**Re: Lane Cove Data Centre – summary of changes for resubmission
Addendum Bushfire Protection Assessment, Vegetation Management Plan,
Watercourse Assessment Report
1 Sirius Road, Lane Cove West**

Travers bushfire & ecology (TBE) has been requested to provide a summary of the changes undertaken to the following reports since the previous July issue of the reports;

Figure 1 – Access design (July scheme)

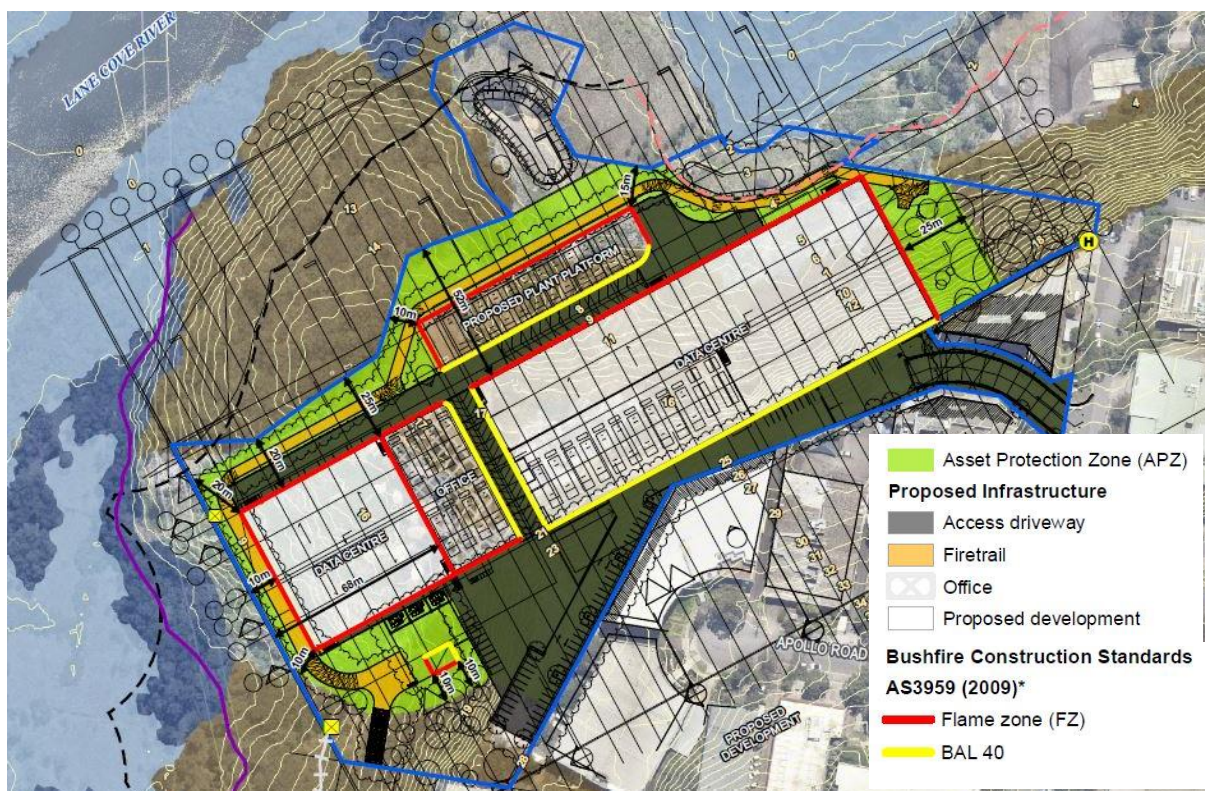
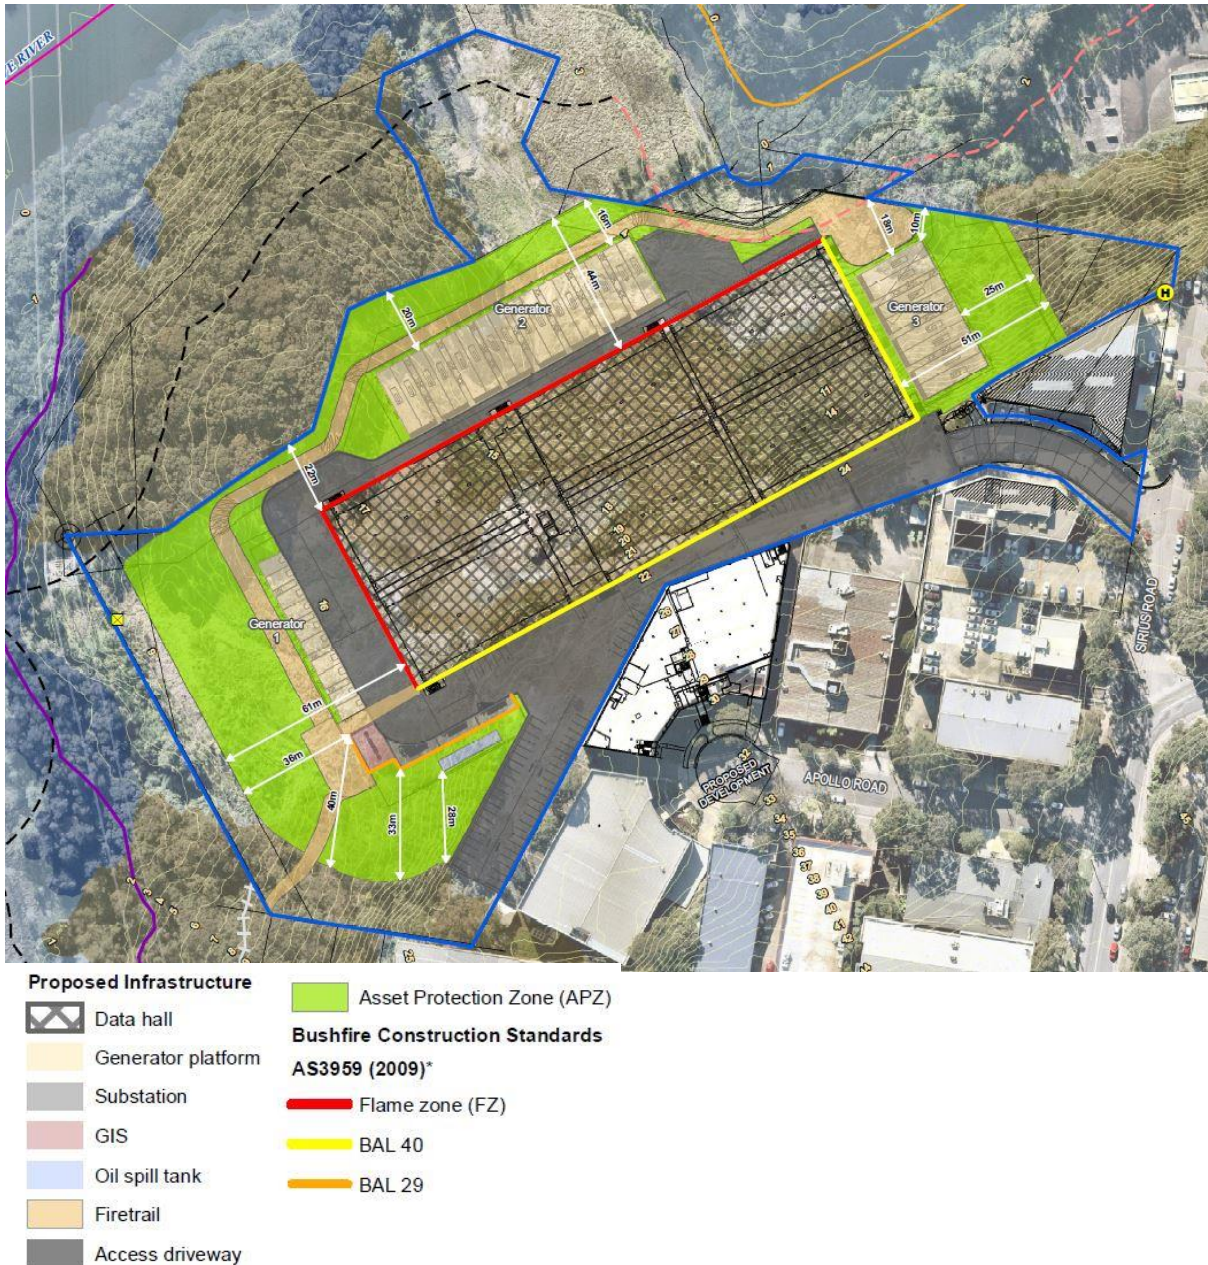
Changes to the driveway include the provision of property access road around the southern, western and northern perimeter of the data centre building. The previous design depicted an access road through the centre of the site between the office and the data centre (refer Figure 1 – access in grey)

The changes to the fire trail design are outlined in Figure 1 & 2 above. The general alignment of the fire trail in the north remains the same. The fire trail in the west now runs adjacent to the generator platform and not adjacent to the western boundary therefore allowing for the retention / regeneration of trees within the western site boundary.

As outlined in the addendum bushfire report the revised scheme maintains compliance with the NSW RFS conditions for private roads. The revised scheme provides additional firefighting access and increased defendable space around the perimeter of the building therefore improving the bushfire protection measures afforded to the development.
